Product Change Notification

Change Notification #: 818686-01

Change Title: Intel® Ethernet SFP28 SR Optic
Reason for Revision: Typo error on MPN P/N FTLF8538P5BCL-IT should be FTLF8538P5BCV-IT

Change Detail: Update MFG P/N and Add a 2nd Source

Latch Change

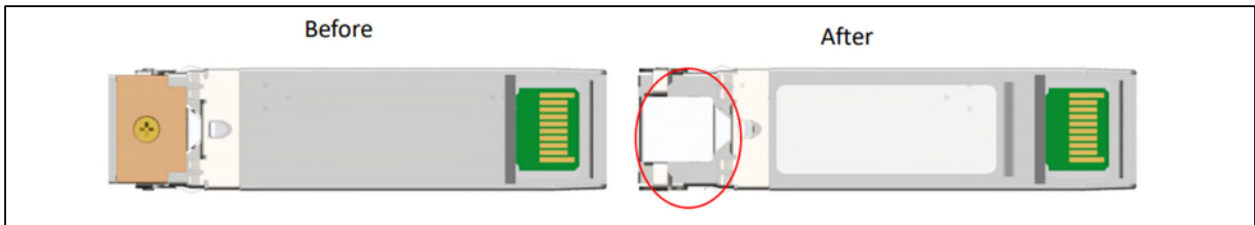
1. The original supplier is adding a manufacturing site in Thailand resulting in a change to the manufacturer's part number (MFG P/N). The new MFG P/N that will be printed on the label is LTF8505-BC-IN1. The parts manufactured at the new site will incorporate an updated external optical housing latch to improve locking and unlocking, removal of the bottom side cover and screw, an increased bottom side label groove for label placement and a replacement laser driver and transimpedance amplifier (TIA) component.

Cover and Screw Removed
